DOCKET
02-AFC-1C

Subject: **Blythe Energy Project Phase II Amendment (02-AFC-1C)**

On behalf of Caithness Blythe II, LLC (Caithness), Galati & Blek LLP hereby submits the Blythe Energy Project Phase II Amendment.

FIGURE 1-1

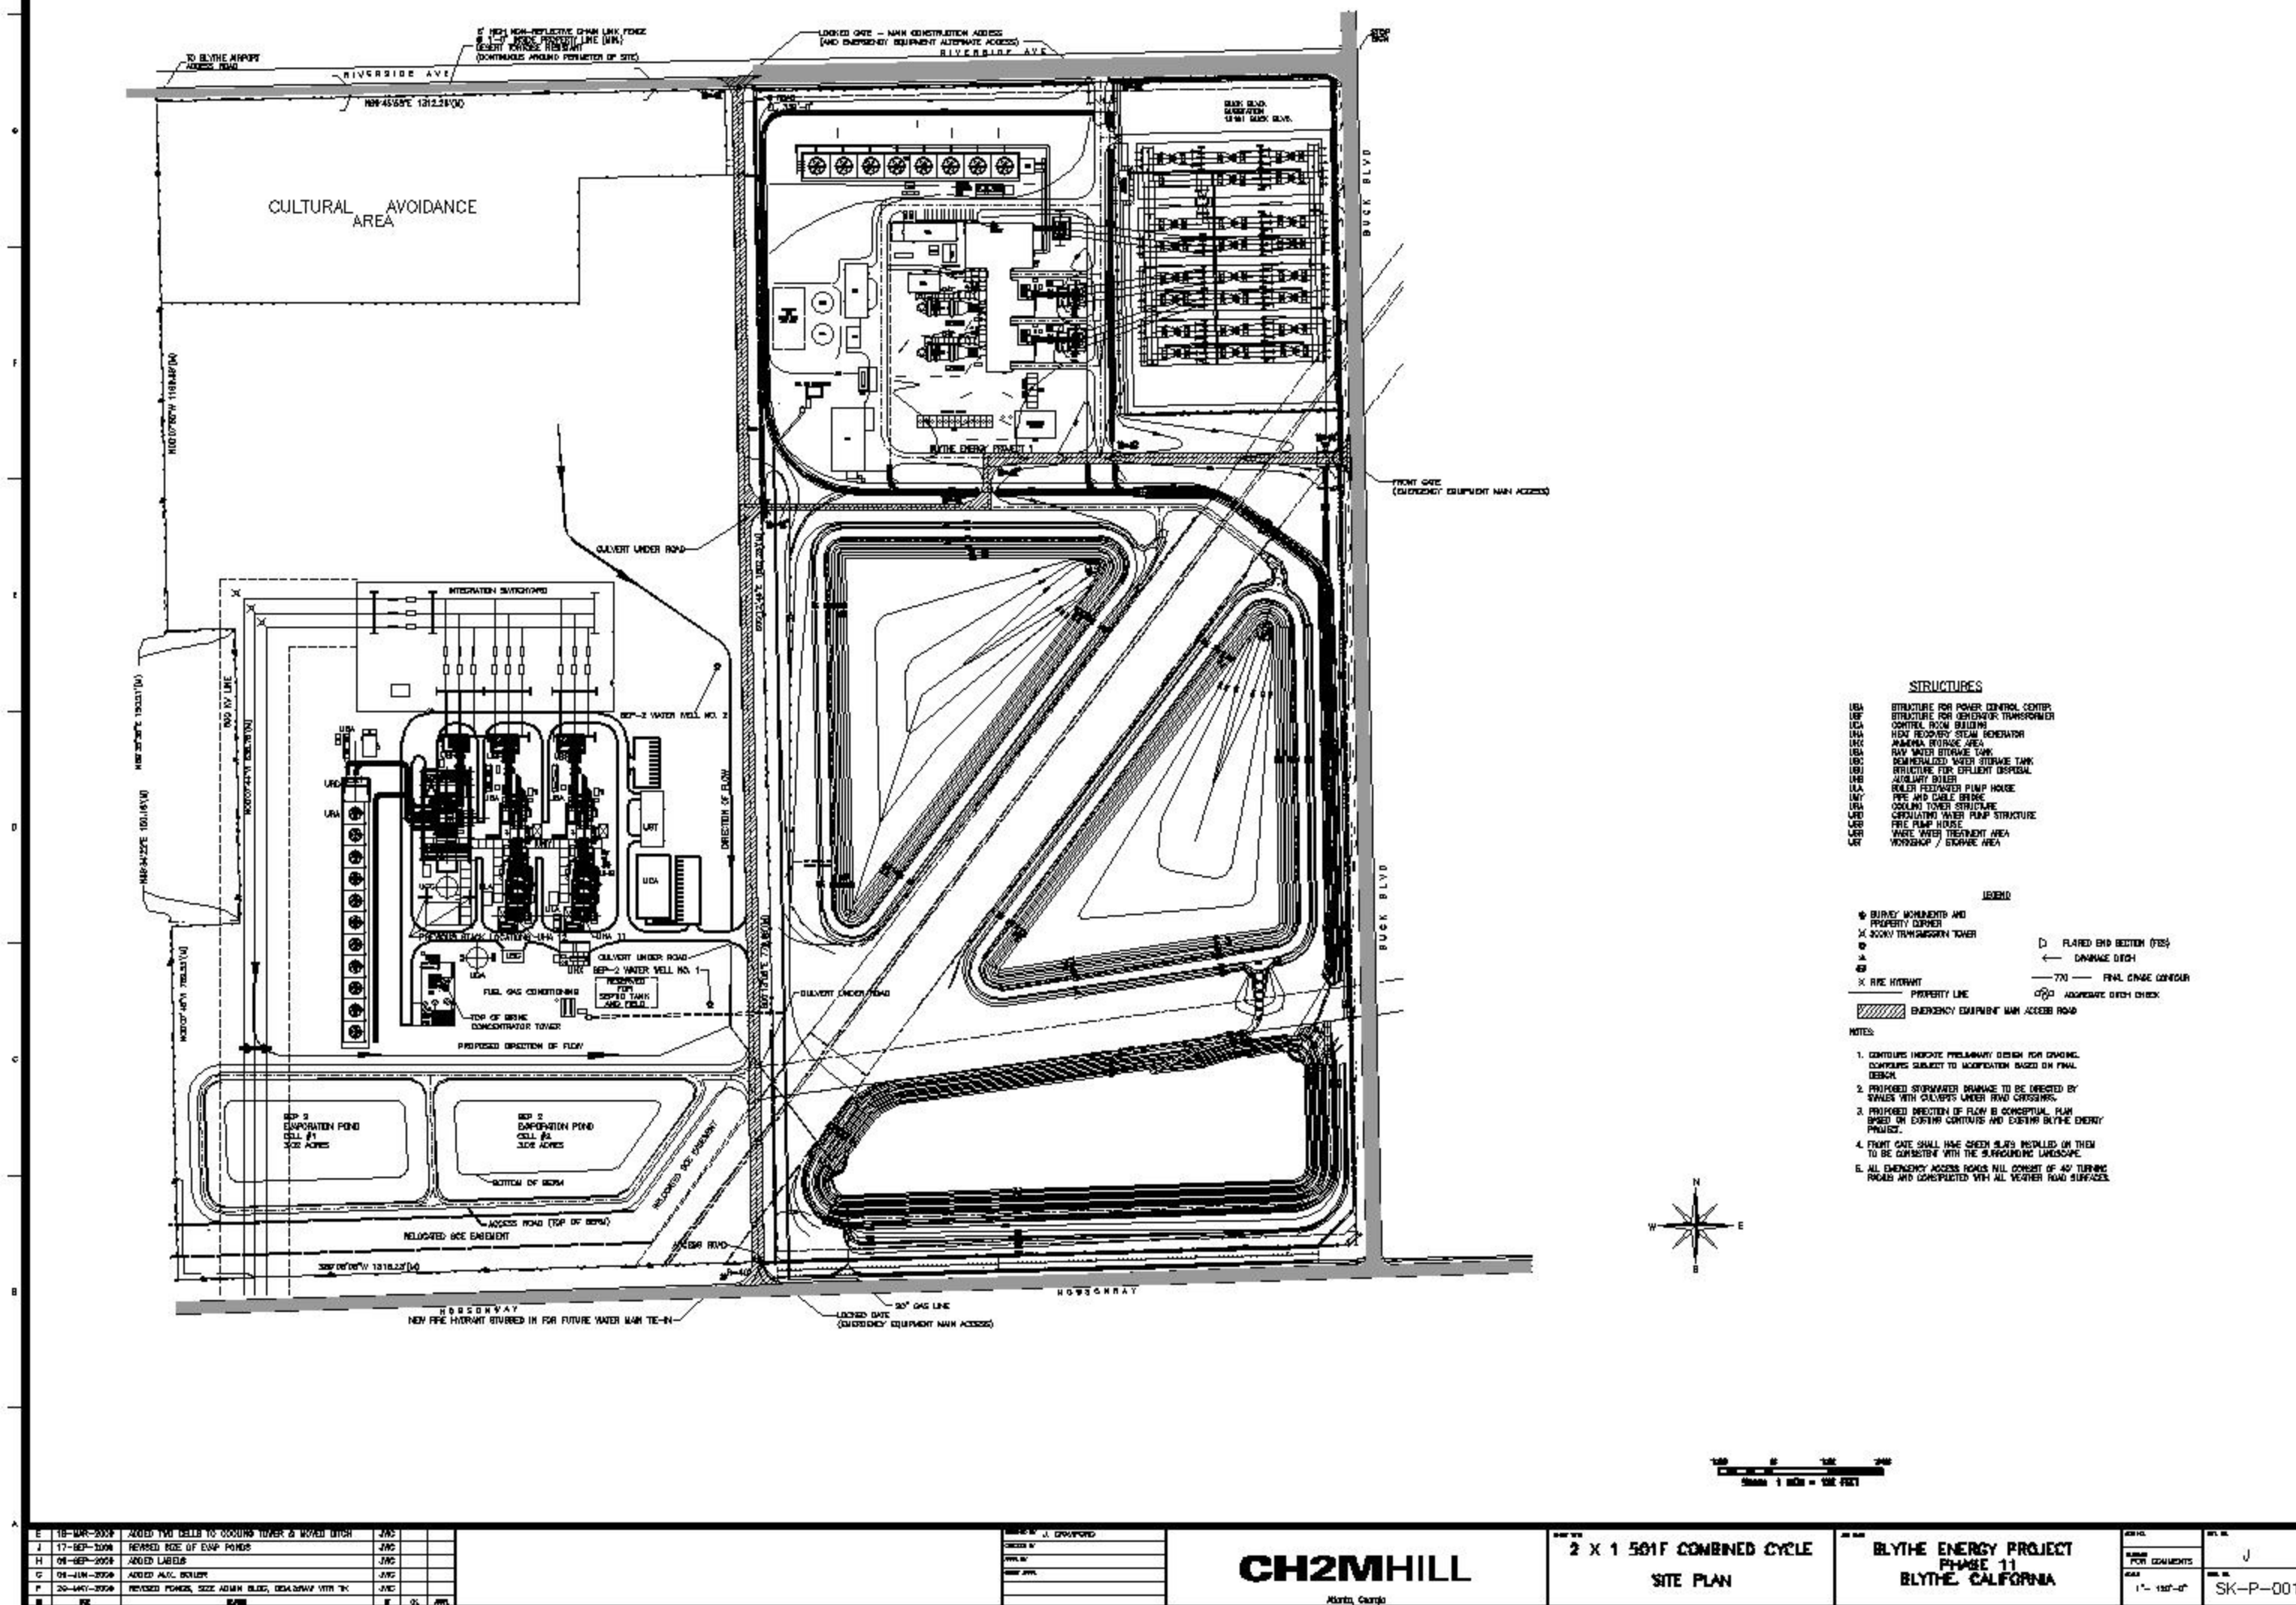
The General Arrangement of the plant will be modified to optimize the location of the facilities with the Siemens SGT6-5000F turbine generators, larger steam turbine generator and their respective enclosures.

Shifting the BEP II slightly east within the 76 acre site will allow the proposed transmission route to run north-south on the western portion of the Project site and connect directly into the permitted Keim Station, located just south of the site. Moving the plant slightly east moves the plant further from the airport and helps minimize the transmission footprint. The Project's revised site plan and general arrangement is shown on Figure 1-1.

Other structures such as the control building will be moved from the west side of the power block to the east side. The parking lot associated with the control building will move as well, and additional parking is proposed just north of the revised control room building location. The

FIGURE 1-2

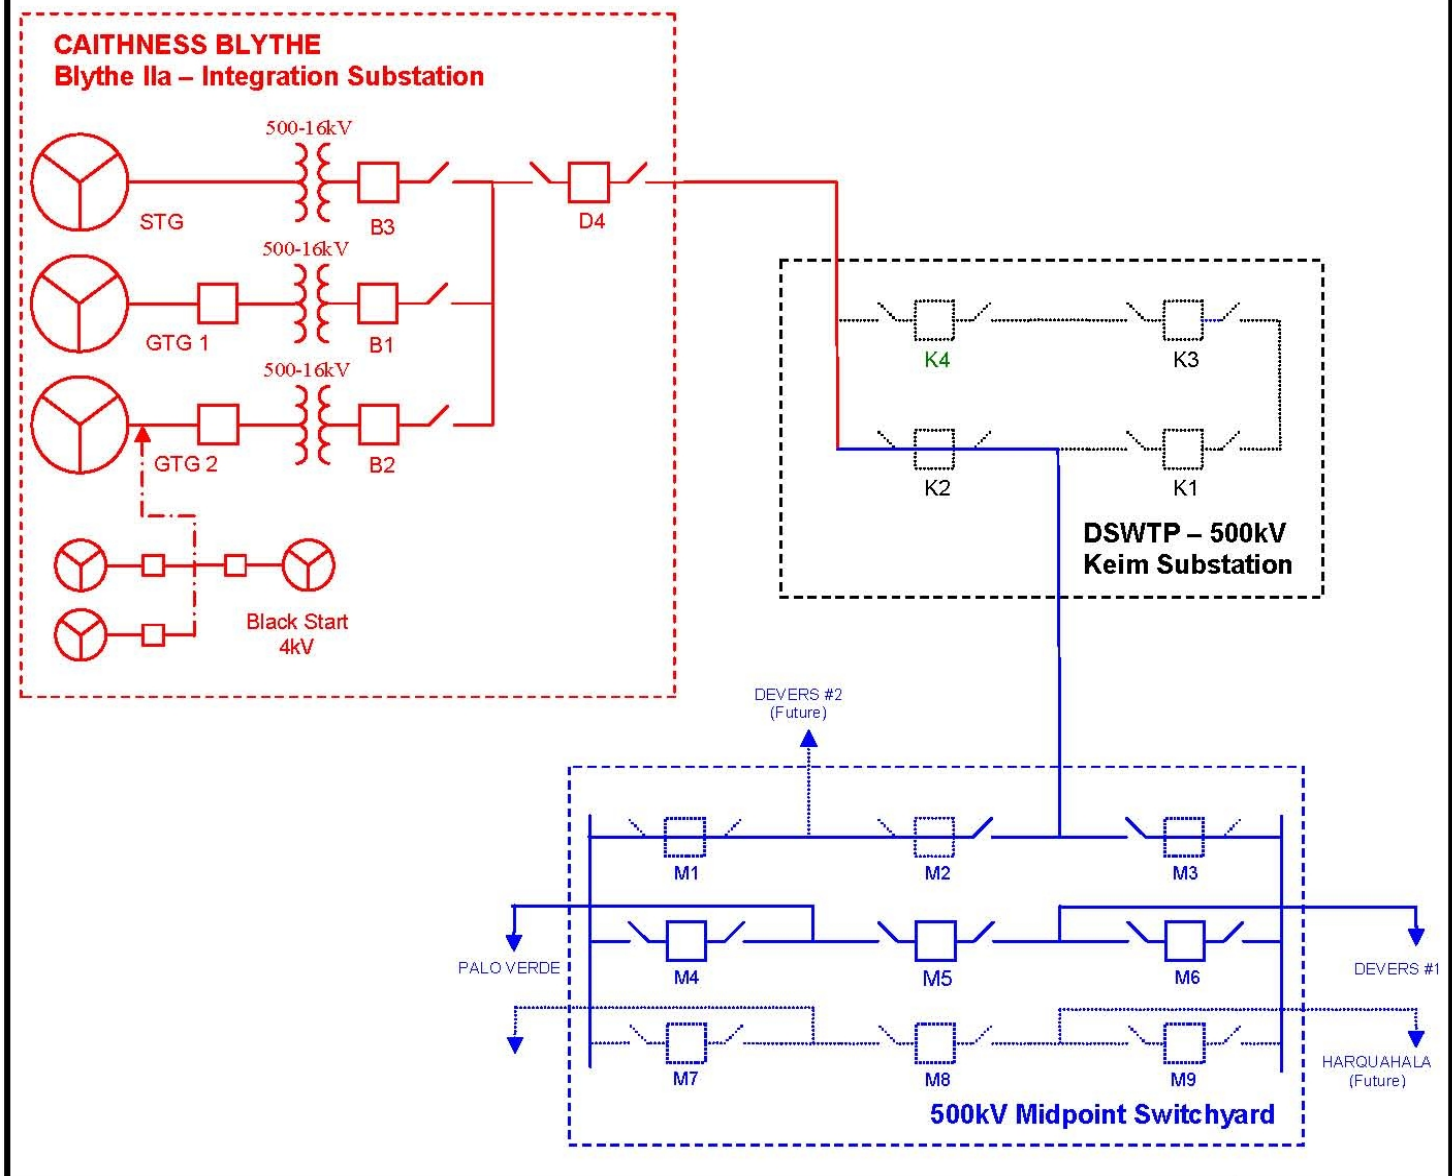
The BEP II Integration Substation is located to the north of the power island will include three main 16/500 kV transformers one for each of the CT's and STG (see Figure 1-2). A 500 kV collector bus will take the power west on a single overhead 500 kV circuit and then south along the western boundary of the site to the site fence line. The line then crosses Hobsonway where it connects to the DSWTP Keim Station.
